Office Action Summary

This is the second office action for serial number 10/058,769, entitled Moving Yoke, in response to Amendment A filed on June 20, 2003.

F. V. FLYNT
SEMICIRCULAR TYPE SUPPORT AND DRIVE FOR
RECEIVER PARABOLA STABILIZATION
Filed Aug. 28, 1946

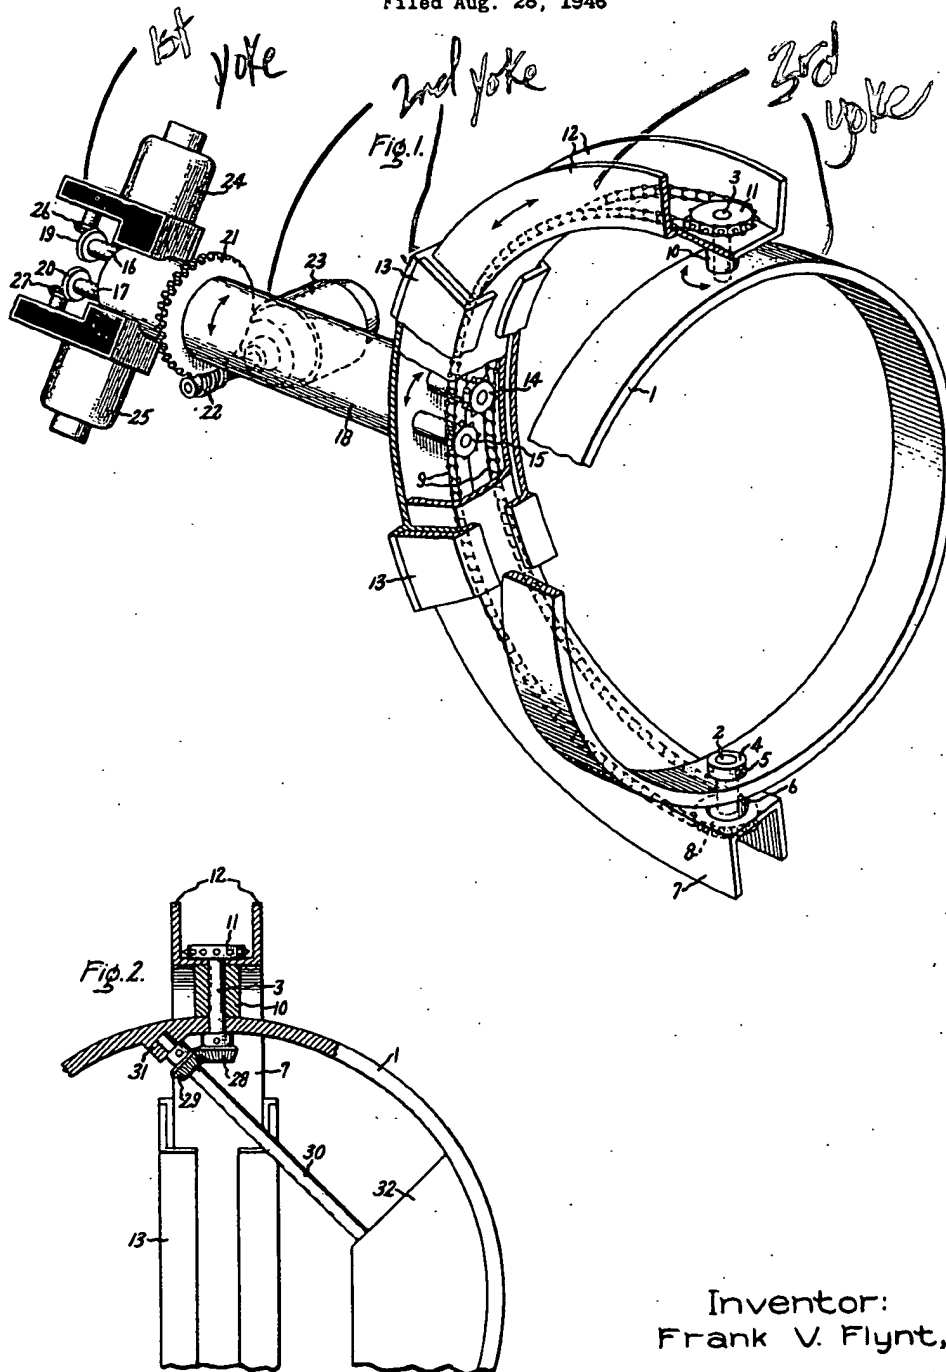
Claims 10-12, 14-21 (as best understood in regards to claim 16) are rejected under 35 U.S.C. 102(b) as being anticipated by Flynt 2,512,636. Flynt discloses a first yoke (L-shaped brackets attached to motors 24 and 25); second yoke (18 and 13) having an arcuate portion and at least one pinion gear (14 and 15); third yoke having two parts rotatable relative to one another, one said part (7) having an arcuate rack (9), and another part (1), means for supporting an object for pivotable movement about a second axis (10); power means being electric motors (23-25). The third yoke is slidable relative to the second yoke.

Claim 13 is rejected under 35 U.S.C. 103(a) as being unpatentable over Flynt in view of Saldana, Sr. (Saldana) 5,690,420. Flynt discloses all of the limitations of the claimed invention except for the light source. Saldana teaches
